SHOREHAM NUCLEAR POWER STATION

SNRC-546

SER REVIEW  
Shoreham Nuclear Power Station - Unit 1  
Docket No. 50-322

ATTACHMENTS TO SNRC-546

SIMPLIFIED SCHEMATIC OF MODIFIED  
CRD HYDRAULIC SYSTEM

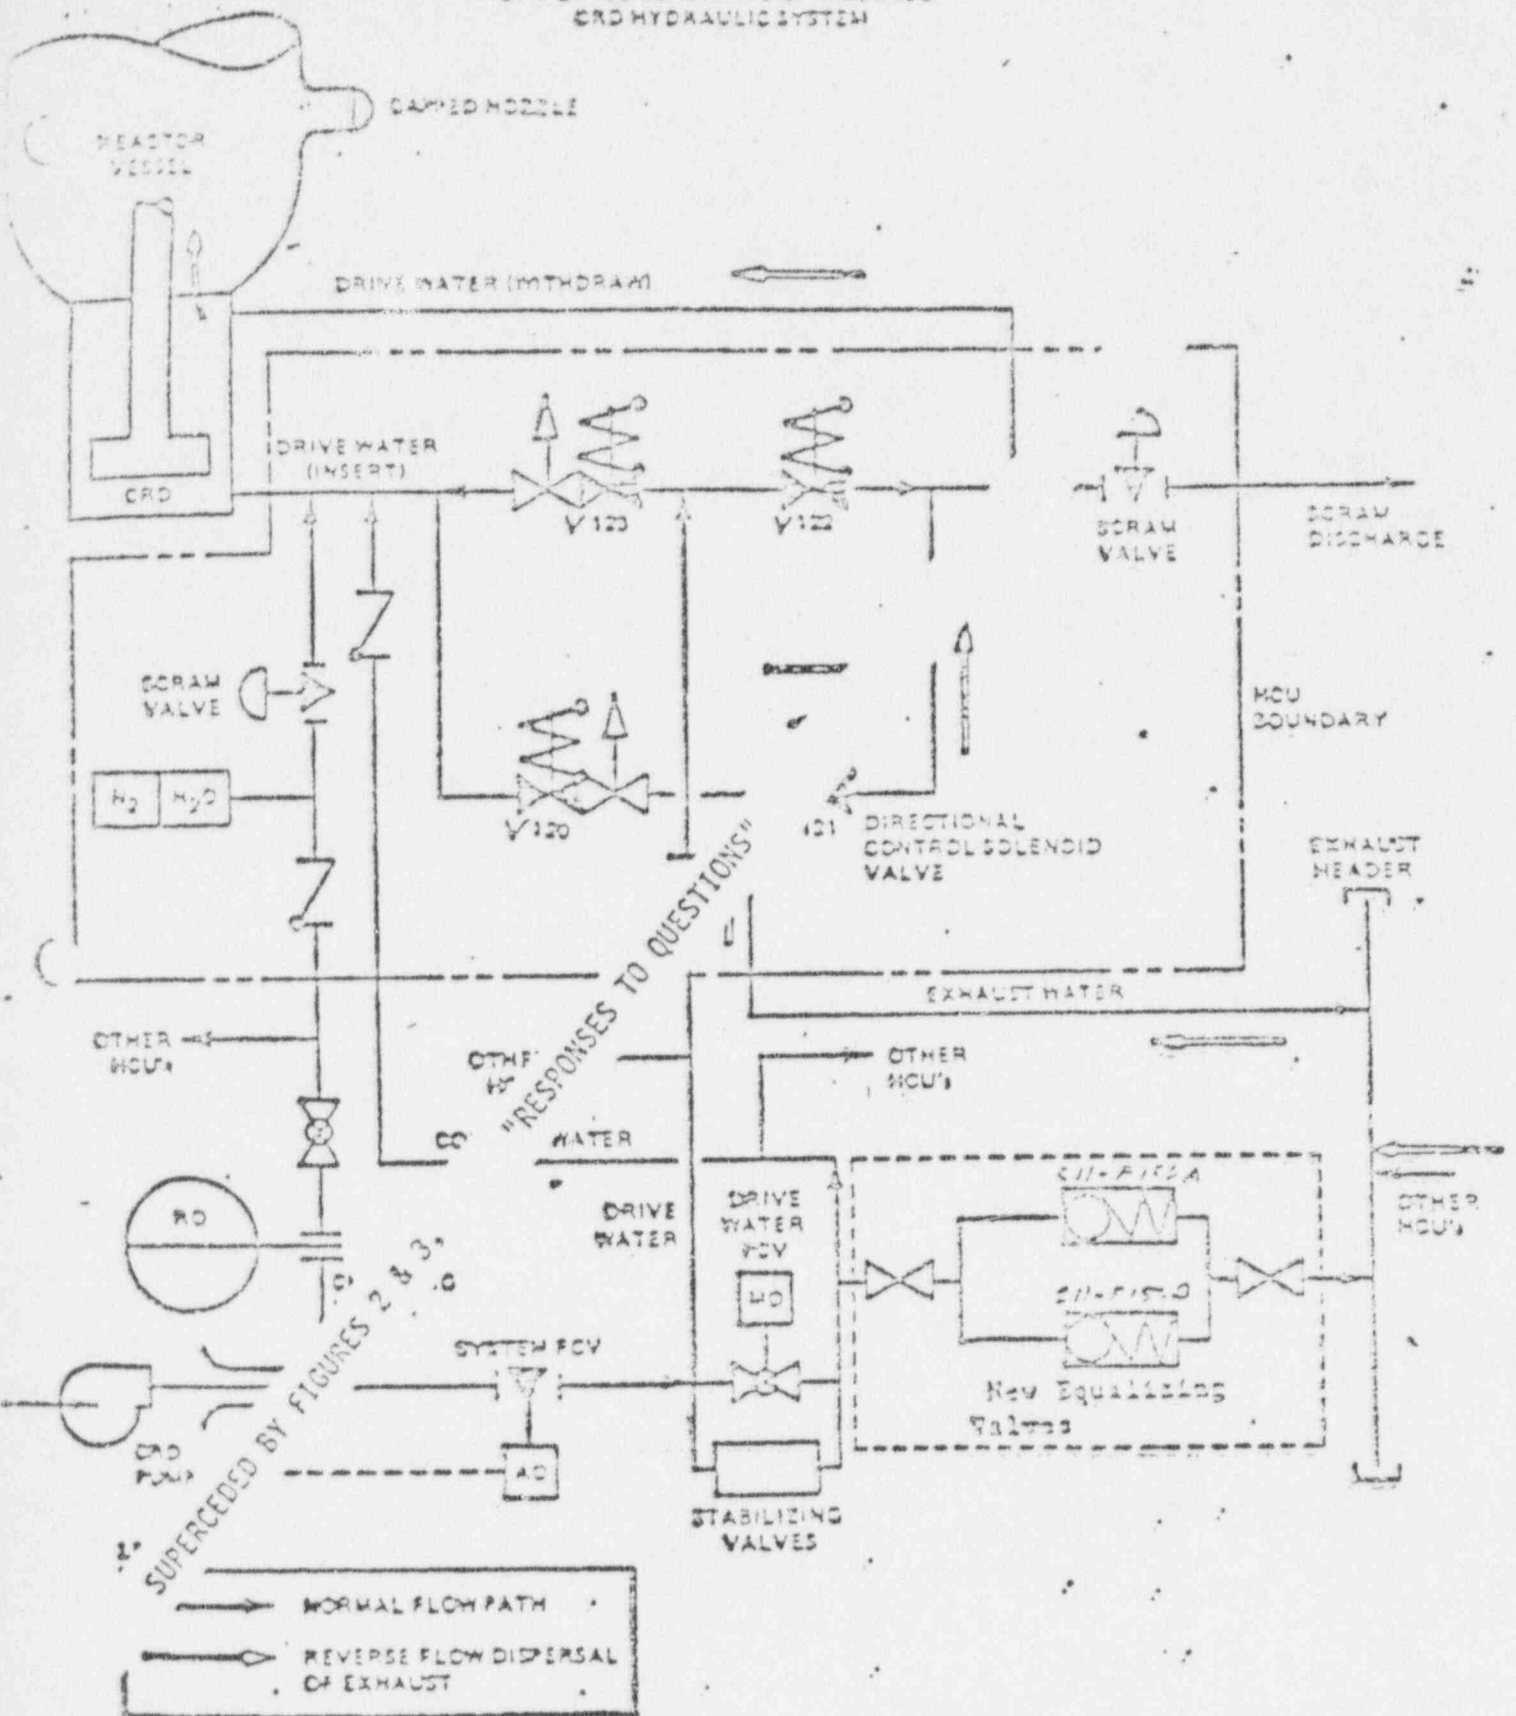
1. Cooling Water Pressure Control Valve - Remove or open permanently.
2. Equalizing Valves (Valve Number F150) - Add two valves as shown in Figure 2 between the cooling water line and the exhaust header to re-pressurize the exhaust header following a scram and prevent excessively high CRD operating differential pressure during subsequent operation of a selected CRD.
3. Exhaust Header Check Valve - Remove and cap exhaust header.

Removal of the return line, capping the vessel nozzle and isolating the exhaust header from the CRD pump discharge as shown in Figure 2 are acceptable as long as the CRDs operate satisfactorily and the makeup capability is acceptable. In-service inspection requirements are reduced, and cycling duty on the 121 valves is limited to periods of CRD operation. One unit is reported to be operating in this mode.

SIMPLIFIED SCHEMATIC OF MODIFIED  
ERD HYDRAULIC SYSTEM  
(Flow Stabilizer Loop Rerouted)

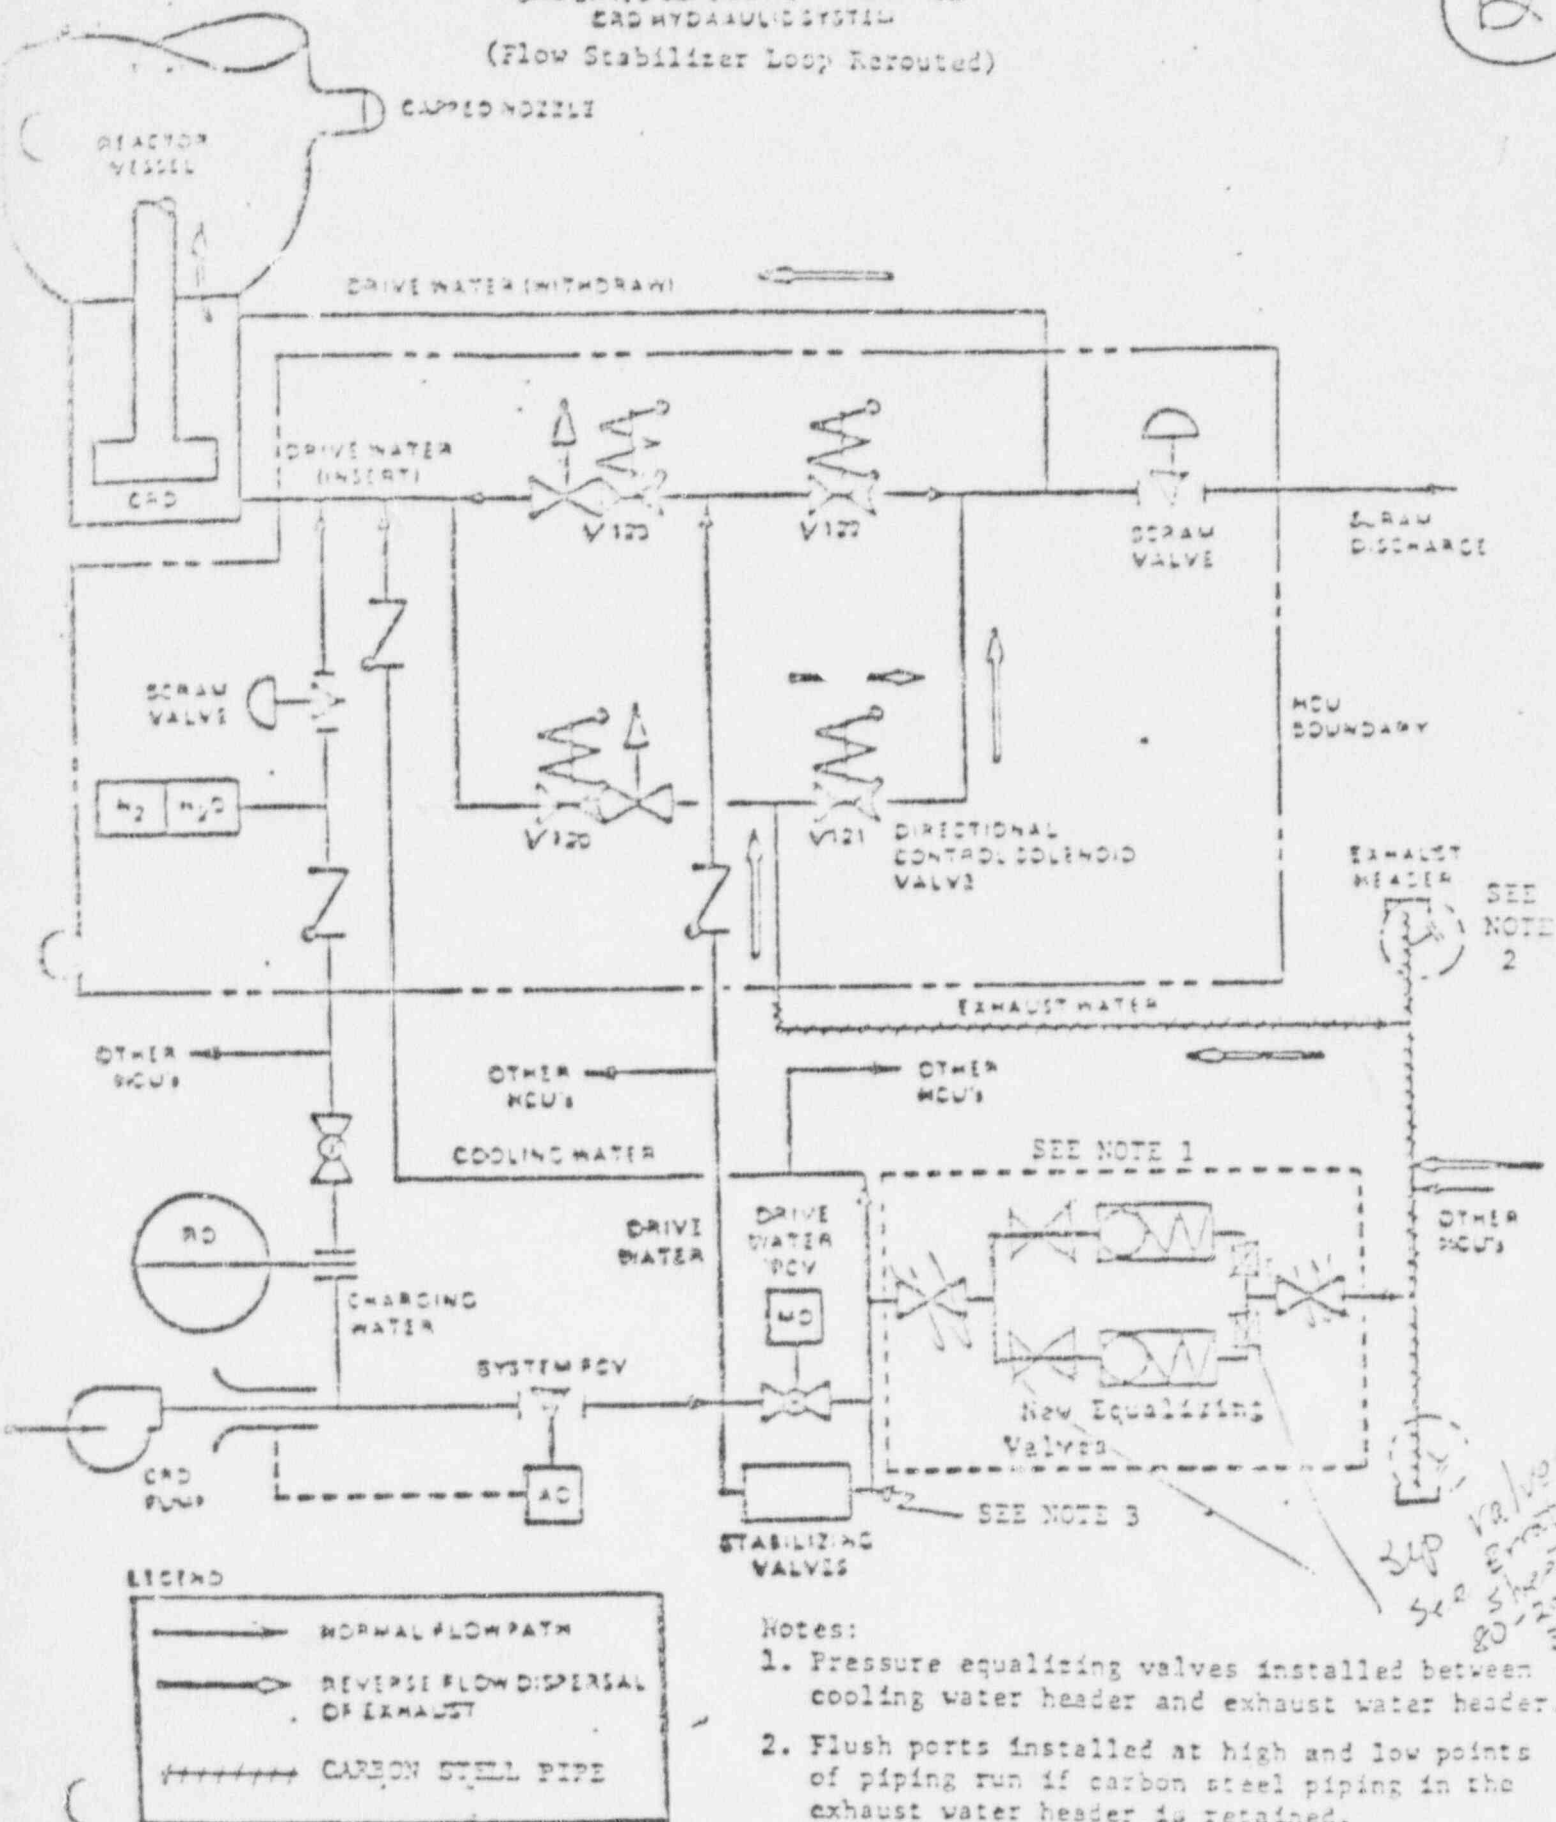
- c. Explain why the 50 micron particulate filters are not shown on Figure 2 of the modified CRD hydraulic system.

The GE recommendation is to eliminate the carbon steel in the flow stabilizer loop. With this run of carbon steel pipe eliminated, there is no flow downstream of the main drive water filters which passes through carbon steel and thus, no need to filter the cooling water flow. Therefore, the referenced figure depicts the flow stabilizer loop rerouted directly to the cooling water header and all carbon steel eliminated from this flow path.
